**OCTOBER 7, 2025**

# **SOFTWARE UPDATE V.400.18 FOR V3242-02BOARD SOFTWARE UPDATE V.500.18 FOR V3242-03BOARD**

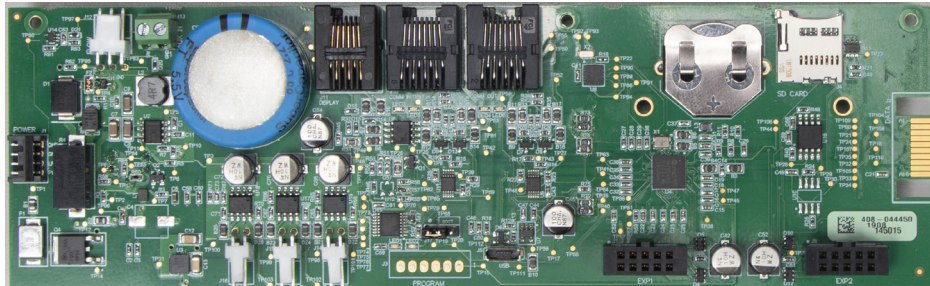
Rev 1: First generation board produced 3/27/2020 – 8/5/2020.

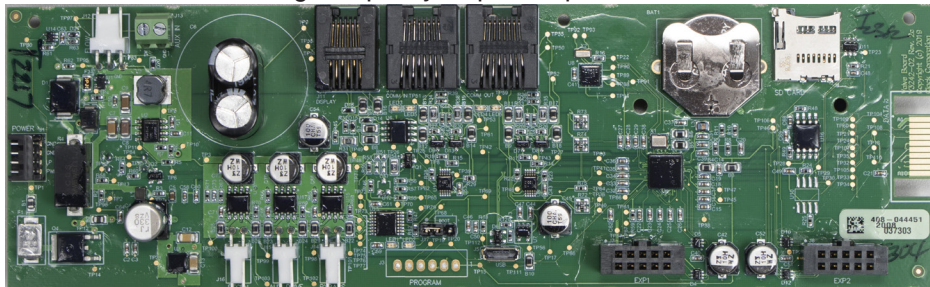
Rev 2c: Doubled the High-Capacity Capacitor produced 8/5/2020 – 1/8/2021.

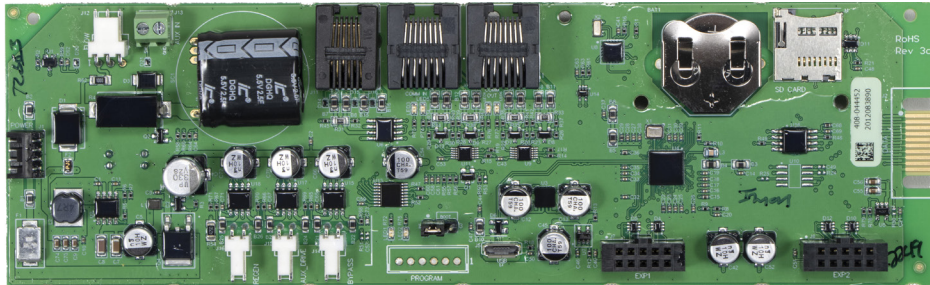
Rev 3c: Latest board version released on 1/8/2021.
